- ALNRC 000021 "AmerenUE Callaway Plant Unit 2 (NRC Docket No. 52-037) Response to RAI No. 15 (eRAI 2599), Revision 0, SRP Section
14.02, Initial Plant Test Program-Design Certification and New License Applicants"

- ALNRC 00034 "AmerenUE, Callaway Plant Unit 2 (NRC Docket No. 52-037) Response to RAI No. 8 (eRAI 2478), Revision 0, SRP Section
03.06.03 – Leak-Before-Break Evaluation Procedures"

- ALNRC 00027 "AmerenUE, Callaway Plant Unit 2 (NRC Docket No. 52-037) Response to RAI No. 13 (eRAI 2497), Revision 0, SRP Section
08.01-Electrical Power"

- ALNRC 000028 "AmerenUE, Callaway Plant Unit 2 (NRC Docket No. 52-037) Response to RAI No. 12 (eRAI 2447), Revision 0, SRP Section
03.11 – Environmental Qualification of Mechanical and Electrical Equipment"

Figure 8.3-1—[Emergency Power Supply System Single Line Drawing - Sheet 1 of 3]

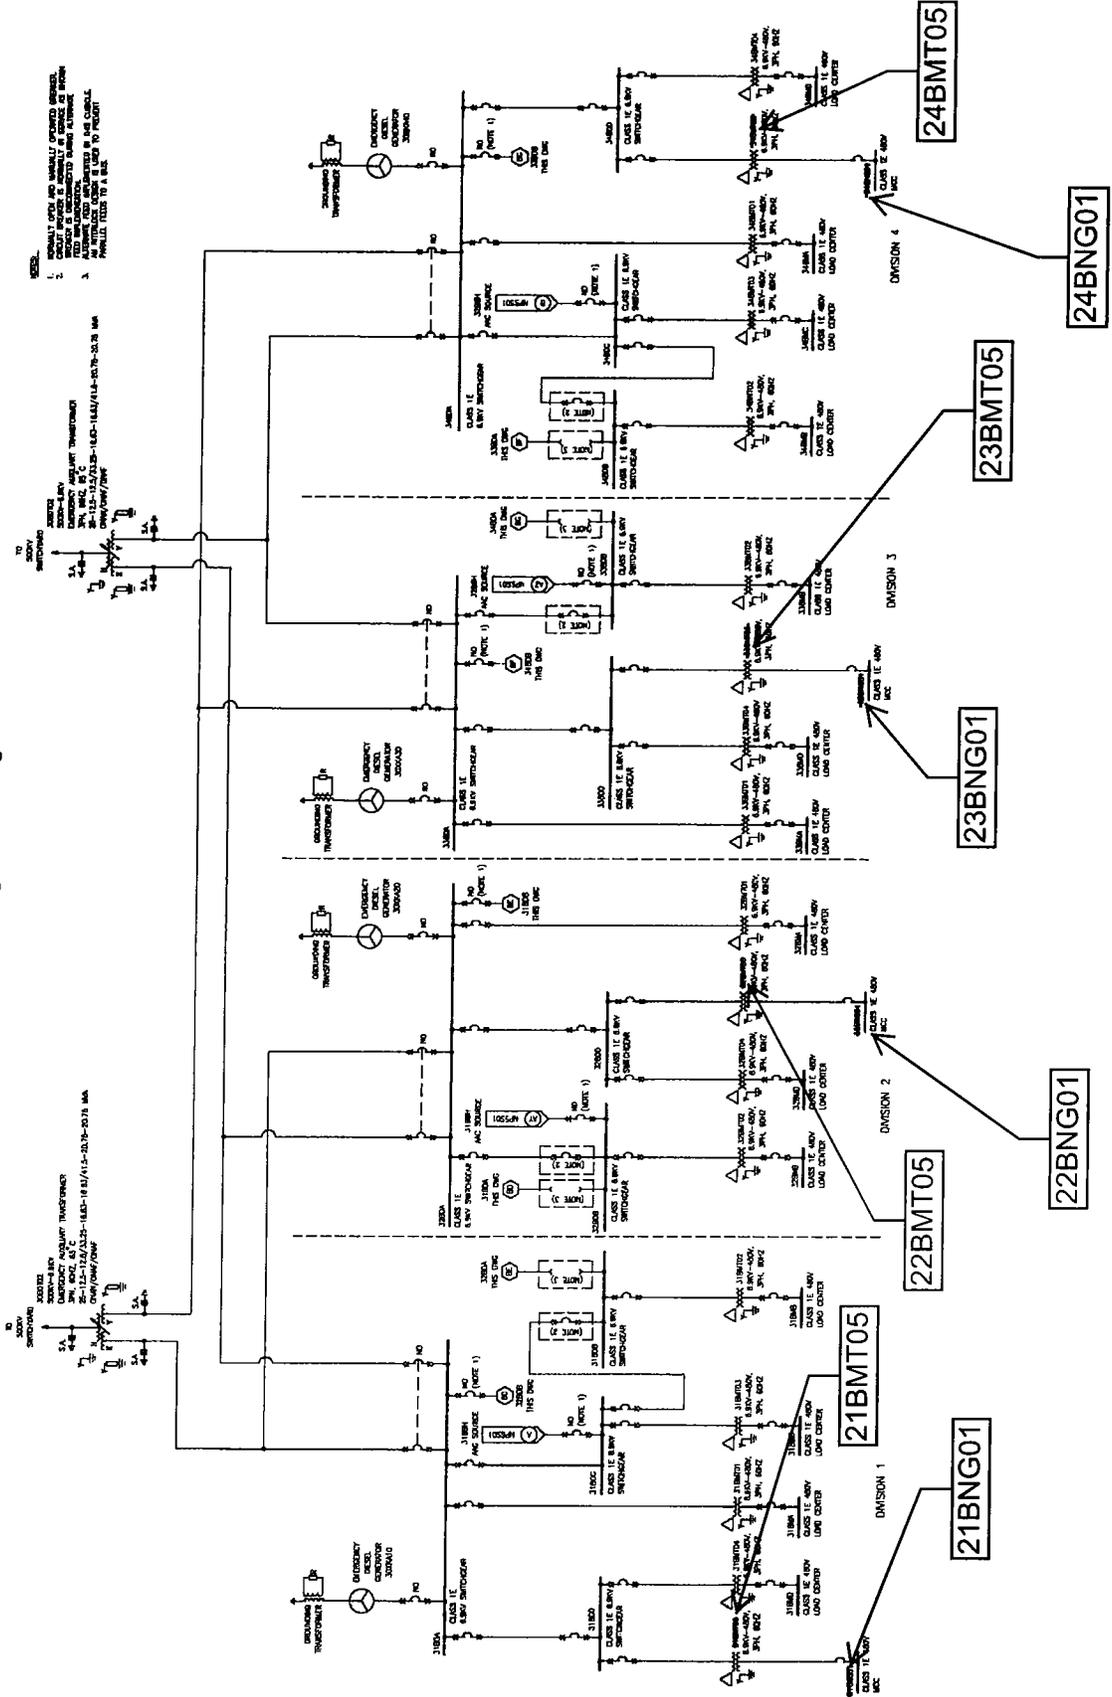
FSAR Table 3.11-1, page 3-210 states: "Verify the Tag Numbers of the ESWEMS Pumphouse Class 1E 6.9 kV-480 V transformers and ESWEMS Class 1E Motor Control Centers." These are inconsistent with the Tag No.s for the same equipment shown in Figure 8.3-1, "EPSS Single Line Diagram." Please reconcile the inconsistency and amend your FSAR accordingly.

The tag numbers for the ESWEMS Pumphouse Class 1E equipment given in FSAR Table 3.11-1 are correct. The tag numbers given for the same equipment shown in Figures 8.3-1 through 8.3-3 "Emergency Power Supply System Single Line Drawing" and Tables 8.3-1 through 8.3-2 are incorrect and will be revised to reflect the numbers provided in Table 3.11-1 as shown in Enclosure 3, Proposed COLA Changes Associated with the Response to Question 03.11-2.

FSAR Figures 8.3-1, through 8.3-3 and Tables 8.3-1 through 8.3-2 will be revised to reflect correct tag numbers for the ESWEMS Pumphouse Class 1E electrical equipment as shown in Enclosure 3 during the next formal revision of the Callaway Plant Unit 2 COLA.
